**Subject: Limited Geotechnical Recommendations for New Fence Wall
Portland Industrial Services
1033 Southeast Woodstock Boulevard
Portland, Multnomah County, Oregon
City of Portland Application # 21-096435-000-00-CO
EEI Report No. 21-248-1-R1**

SITE DEVELOPMENT CHECKSHEET

Application #: **21-096435-000-00-CO**

Figure 1: Site plan showing the location of the proposed fence wall *in blue* (base drawing source: S2 by M-Group).

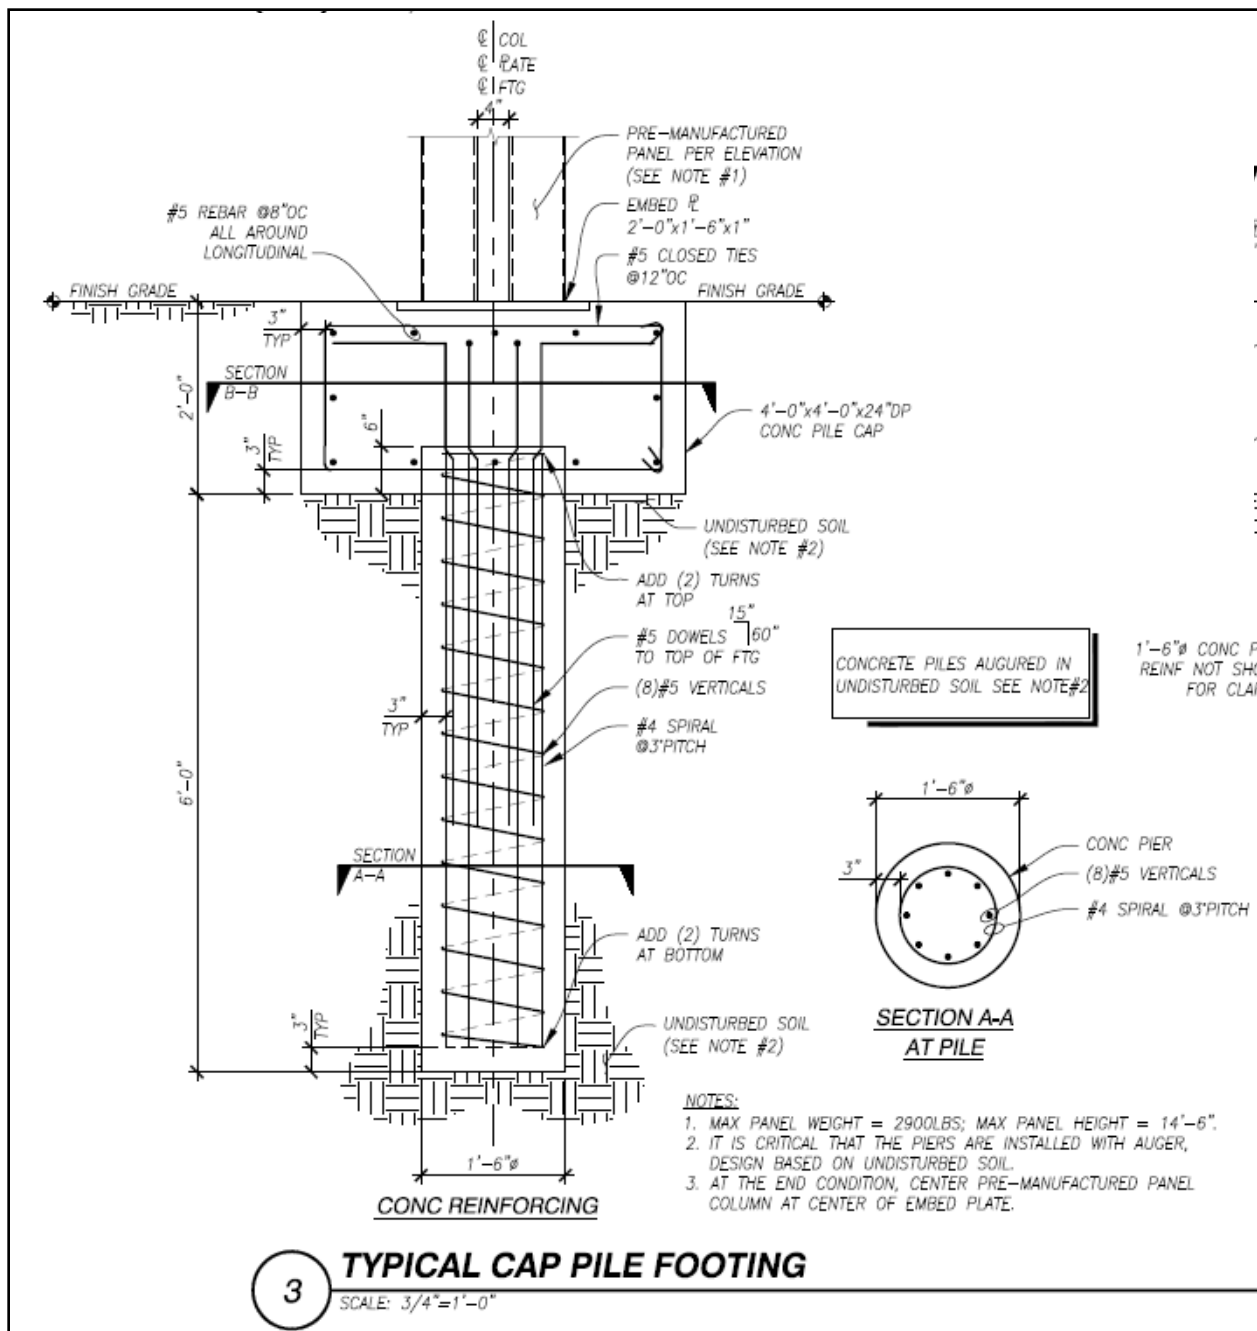
Checksheet Item #1 indicates that soils special inspection will be required. **As a condition of issuing this report, we are requiring that we be retained to perform the soils special inspections required by the City of Portland and the structural drawings—this is consistent with what the City of Portland is requiring as part of the building permit.**

Checksheet Item #2 discusses whether the pile head should be considered to be in a restrained or non-restrained condition at the ground surface. While this is ultimately a structural issue that should be satisfied by the Structural Engineer, we can comment that it is our understanding from speaking with Sam Rediske at M-Group that the pile cap was enlarged and made more rigid (i.e. 4 feet by 4 feet by 2 feet deep) to create a restrained condition for the pile head. In addition, the pile cap design was purposefully embedded by M-Group a significant amount (2 feet) to essentially create a surficial keyway for the piles that provides passive earth pressure to constrain the piles on all sides.

Checksheet Item #3 states that a geotechnical report is required to address the lateral bearing pressure recommendation—as stated above, M-Group assumed a value of 250 psf/foot. So essentially, our scope is to verify whether or not that is an appropriate value for the site soils within the length of the proposed drilled piers (i.e. approximately 8 feet below grade).

A review of our other nearby project files indicates that the soil conditions in this area of Portland typically consist of gravel with silt and sand that is generally medium dense to very dense. **Based on the anticipated generally dense gravelly soils and the relatively conservative lateral earth pressure assumed by M-Group (250 psf/foot), we recommend that the design lateral earth pressure is acceptable from a geotechnical standpoint. In fact, even if the site soils consist of firm silt (not gravel), we would still be comfortable recommending 250 psf/foot.**
